Summary of Submissions:

The tables below summarise the comments received during the advertising period of the proposal, together with the Applicant’s response to each comment.

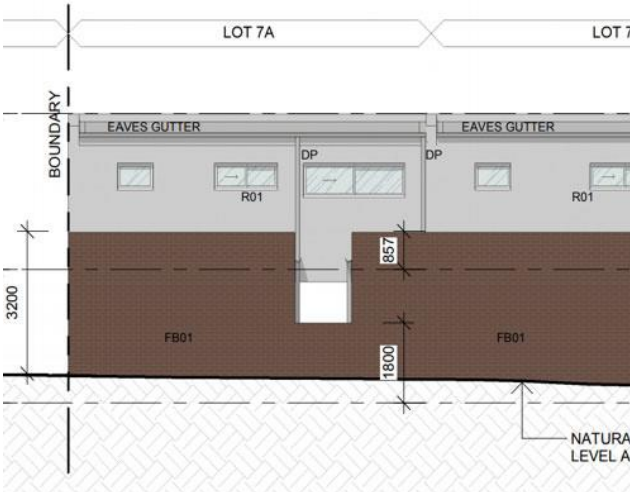
<p>Issue: Building Height</p> <ul style="list-style-type: none"> The three storey building height is excessive for the site and area context, and is non-compliant. 	<p>The height follows extensive consultation with CoV as well as pre-design commencement meetings to discuss the nature, orientation and built form of the townhouses.</p> <p>The orientation, driveway location and number of levels is reflective of a considered and consultative approach incorporating CoV architectural review. The third storey is in the form of loft style elevations which is in character with the area and readily found in the immediate surrounds.</p> <p>The loft elements are set back from the front of the street with substantial articulation. The high elements will not be dominant from the perspective of the public realm. The roof line steps down to a height that is well below deemed to comply height limits to differentiate the townhouses as well as reduce overshadowing.</p> <p>Please also refer to the “SUPPLEMENTARY NEIGHBOURING DWELLING HEIGHT STUDY” attached and further examples of 3 storey dwellings on Florence and immediately adjacent streets.</p> <p>View from rear of 12 Florence – 3 storey blank wall</p>

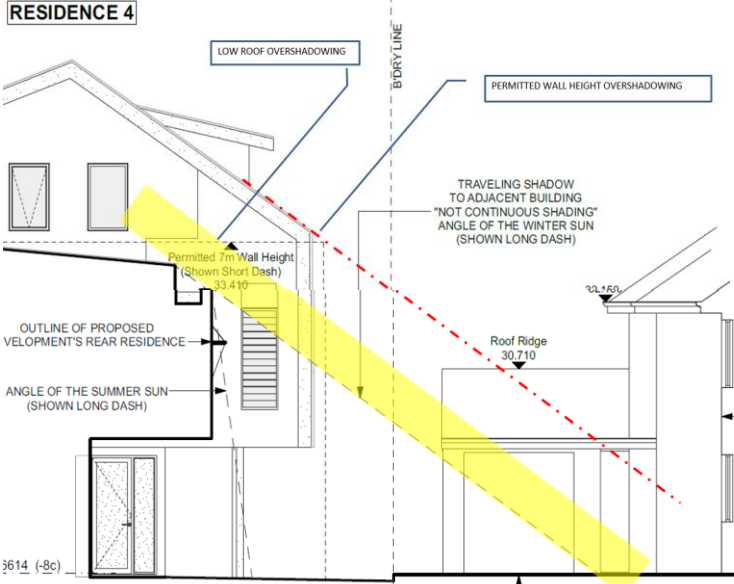
<p>Issue: Overdevelopment</p> <ul style="list-style-type: none"> • The proposal is an overdevelopment of the site. • Reduced setbacks and greater building height result in detrimental bulk impacts on adjoining properties. 	<p>There are several constraints on any built form or design that can be considered for this property. The width and length of the property has a natural geometry for 4 townhouses in a row. Any townhouses installed along the length of the property will have sight line screening or obscured glazing requirements due to the proximity to the boundary.</p> <p>The open space departs from the specified requirements by 2%. The landscaping design and open space exceeds many similar developments. There is significant demand and interest for inner city style developments and it is the opinion of the applicant that this proposal represents a generous and spacious design that does not seek to constrain the enjoyment and use of the dwellings by the occupants. Furthermore, it is not the applicants opinion that this design introduces more dwellings than that which is a reasonable and natural fit for this size of the lot, nor that the construction of this dwelling imposes itself on the neighbouring property. The proposed design has a high construction standard that will further differentiate this development and provide a high merit and pleasing addition to the locality. Visual privacy has been addressed by way of internal courtyards and terraces that significantly promote a sense of views without overlooking. Sight lines form the internal</p>

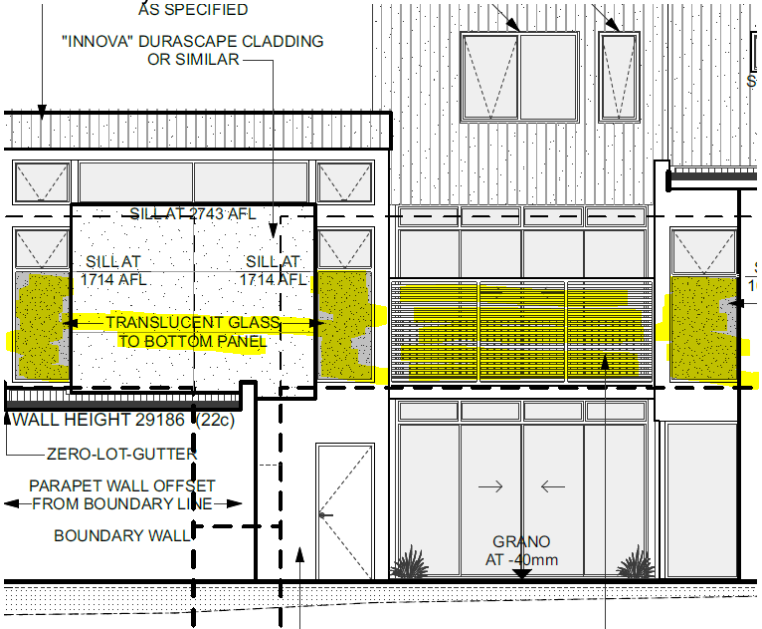
- at 14 Florence Street and overlooking south towards 10 Florence Street dwellings.
- Reduced privacy of 16 Florence Street and dwellings fronting Janet Street.

North aspect windows and terraces include screening. We understand that this includes future lot 7C kitchen and lot 271A outdoor living area.

There are limited windows looking south and these are set back by the width of the driveway.
